PUBLIC NOTICE

**City of Lockhart
Zoning Board of Adjustment
6:30 PM, Monday, December 6, 2021
Municipal Building — Glosserman Room
308 W. San Antonio St.**

ZV-21-08

ZV-21-09

CITY OF LOCKHART - SITE PLAN

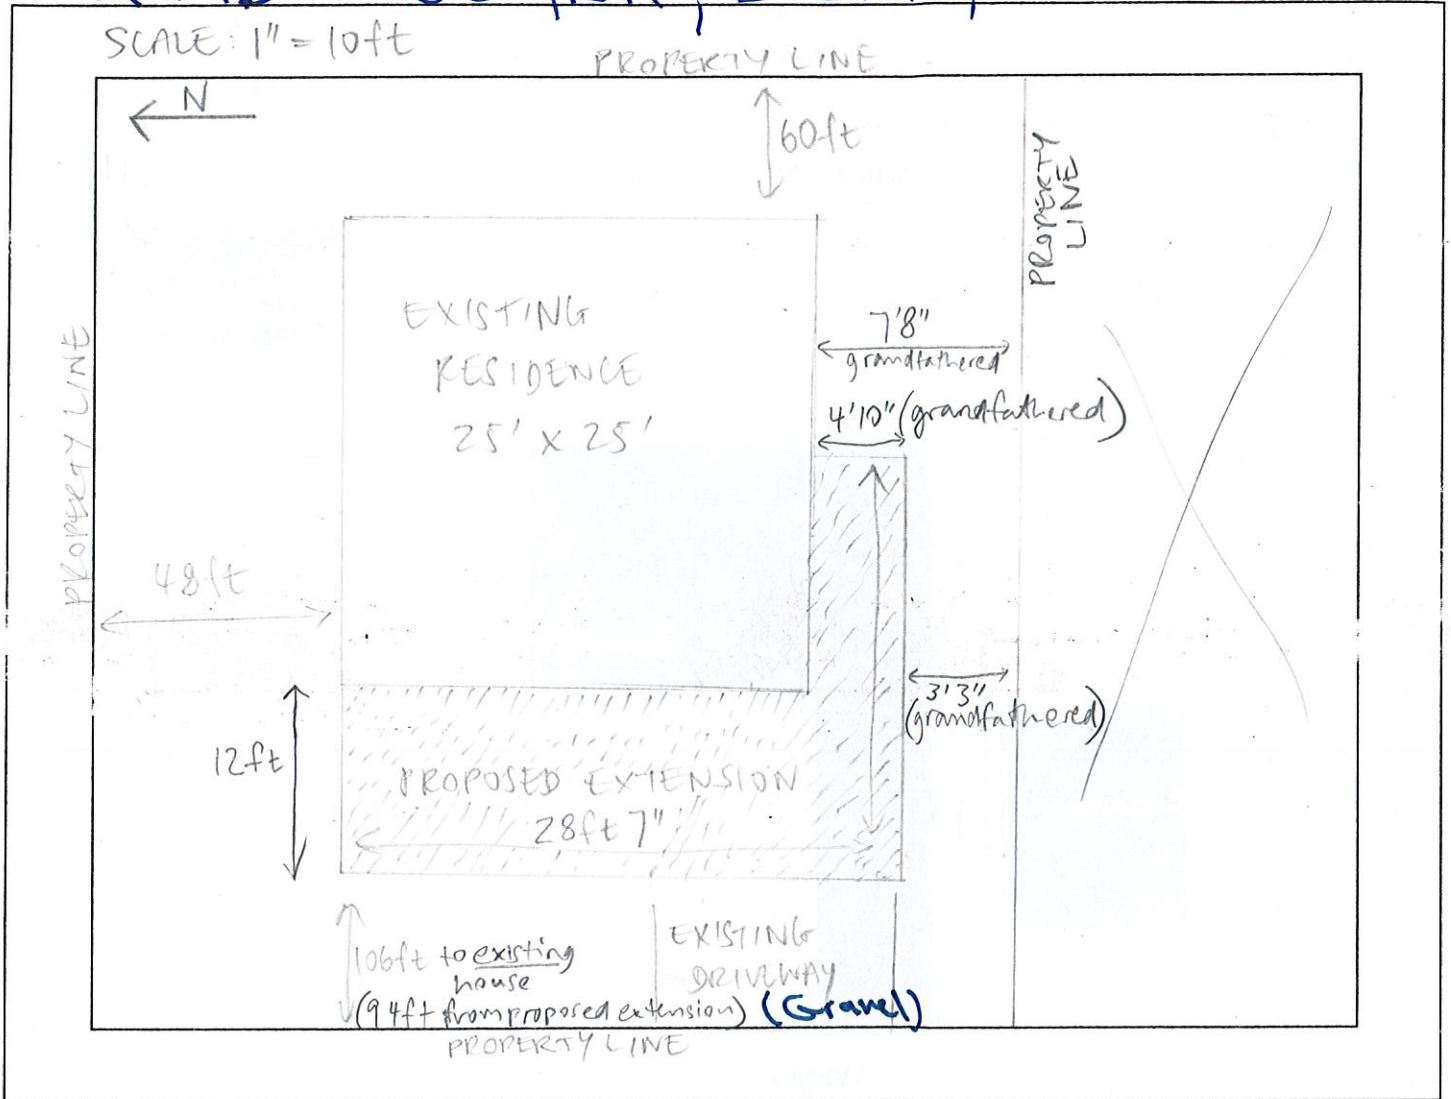
REASON FOR REQUESTED VARIANCE: The applicant proposes to enclose the existing, open-air stairway on the south side of the existing residence by extending the stone wall encompassing the stairs upward to the roof of the house, and extending the roof over the stairway. The existing wall on the south side of the stairs, opposite the house, is three and one-quarter feet from the south (side) property line. Also proposed is the construction of a sunroom addition to the front of the house, which would also extend to three and one-quarter feet from the side property line, flush with the proposed stairway enclosure.

UNIQUE CONDITIONS OF PROPERTY: The applicant explains that the existing stairway's location on the outside of the house creates a unique condition to the property, which presents safety issues when walking from one level of the house to the other due to potential weather hazards that might cause someone to slip when the stairs are wet or icy. The applicant also states that the concrete landing at the top of the stairwell is deteriorating, presenting further safety hazards if the landing were to collapse. Finally, the applicant explains that if the reconstructed stairs were moved closer to the house to meet the required five-foot side-yard setback, they would not meet the minimum 36-inch width required by the Building Codes. Although Staff recognizes and supports the correction of safety hazards associated with the stairwell, the existing conditions do not create a unique condition that warrants an addition to the stairwell area within the required side-yard setback. Further, any construction or reconstruction less than five feet from any property line does not meet the City's Fire Code spacing requirements.

ALTERNATIVE SOLUTIONS: The applicant explains that the reconstruction of the stairs to meet the required setbacks in the same or different exterior location, or in an interior location, is unfeasible, as it would impact the structure's integrity, as discussed above. However, an alternative solution is simply to repair the existing staircase and concrete landing to a safe condition, which would still allow a reasonable use of the property without a variance.

STAFF RECOMMENDATION: Staff recommends denial of the variance request, which does not meet all six of the variance review criteria. The owners were aware of the exposed stairway when they purchased the property. However, this is not grounds for a variance, when safety issues can be repaired without it. While the open stairway is not considered part of the enclosed footprint of the house, the enclosure of the stairway and extending the interior footprint would create a nonconforming situation.

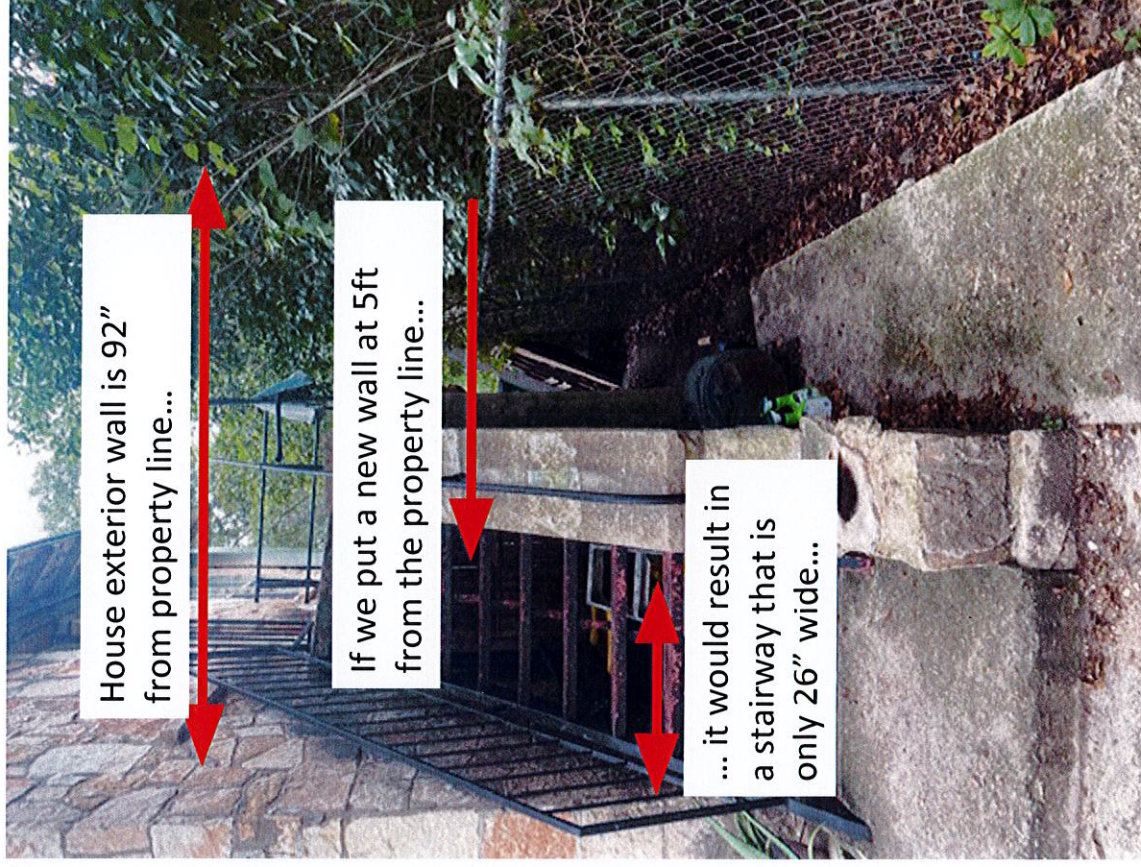
... If we do this, the stairway ends up being only 26" wide:

Exterior wall of house from property line is 92" minus 60" from property line (5ft) = 32"

32" minus 6" thickness of an exterior wall = 26"

Which does not meet code...

Stairway needs to be at least 36" wide.

LANDSCAPE SITE PLAN

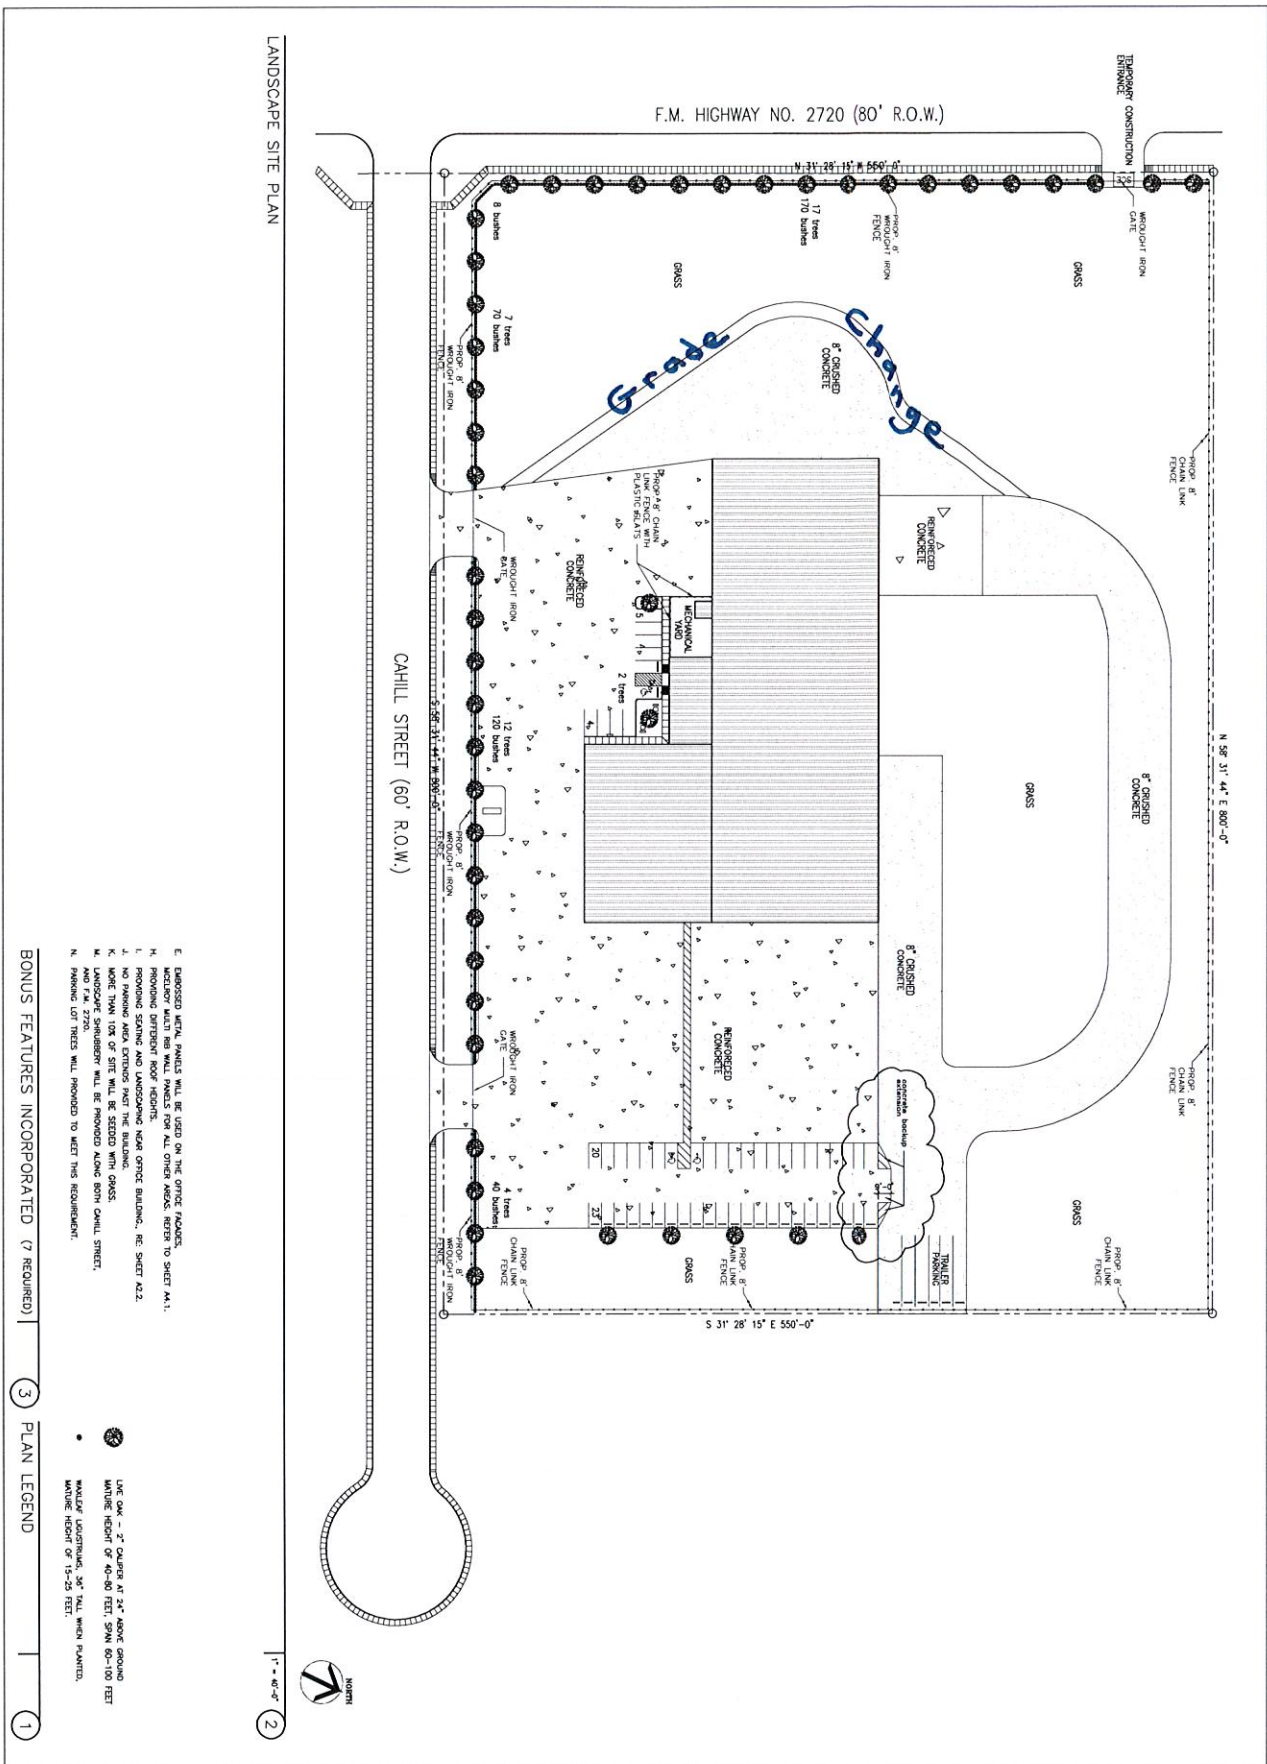
REASON FOR REQUESTED VARIANCE: The applicant proposes to develop the property with an industrial manufacturing facility for the McElroy Metals company. While the main parking area along the south and east sides of the proposed building will be constructed of reinforced concrete, the applicant proposes to utilize a crushed concrete material for a driveway, circulation area, and trailer parking on the north and west sides of the building. The requested variance is to allow the crushed concrete surface and waive the paved, all-weather parking surface requirement set forth in Zoning Ordinance Section 64-197(g)(1)(e)(2) for the areas identified above. The crushed concrete areas will be used by raw material trucks, and will not be visible from Cahill Street according to the applicant. The applicant would like to have the ability to expand the building to the northwest in the future, and explains that reinforced concrete or asphalt is more difficult and expensive to remove than the proposed crushed concrete. The applicant further explains that if the building expansion does not occur within the next ten years, the crushed concrete will be replaced with reinforced concrete or asphalt. The subject property is part of a recently approved subdivision, Lockhart Industrial Park III Section One, the final plat of which was approved by the Planning and Zoning Commission in August 2021. Since the plat has not yet been recorded, the subject lot does not yet legally exist, and no construction activity may commence until after the plat has been recorded and the necessary permits issued.

NATURE OF HARDSHIP: Although there would be reduced financial hardship associated with not paving certain portions of the proposed parking and circulation areas, the request for the variance is not based exclusively upon the applicant's desire to avoid the cost of paving. The applicant states that the primary reason for the variance is to allow for future expansion of the proposed building into the areas proposed with a crushed concrete surface. However, a desire for future expansion does not necessarily constitute a hardship caused by any unique condition of the property.

COMPLIANCE WITH VARIANCE CRITERIA: In order to approve a variance, the Board must find that the request meets all six of the criteria outlined in Section 64-129(a) of the Zoning Ordinance. The applicant submitted the attached written explanation as evidence in support of the variance. Staff believes that the variance request warrants approval, if the Board determines that all six variance criteria are met, except for the area extending from the northeast corner of the building to the east property line. This area will likely see more truck traffic than the other proposed crushed concrete areas, and also includes six trailer parking spaces, which would be better served with an all-weather surface.

PRECEDENT: Staff's suggested compromise to grant a variance for a portion of the area proposed to be crushed concrete, while requiring that the trailer parking and maneuvering area abutting the paved parking lot be an all-weather surface, might avoid setting an undesirable precedent.

ALTERNATIVE SOLUTIONS: An alternative solution includes constructing the proposed crushed concrete areas in accordance with the paved, all-weather surface standards. An all-weather surface is defined as either reinforced concrete, asphalt, or masonry pavers installed in accordance with manufacturer's specifications. This alternative would avoid the need for a variance.
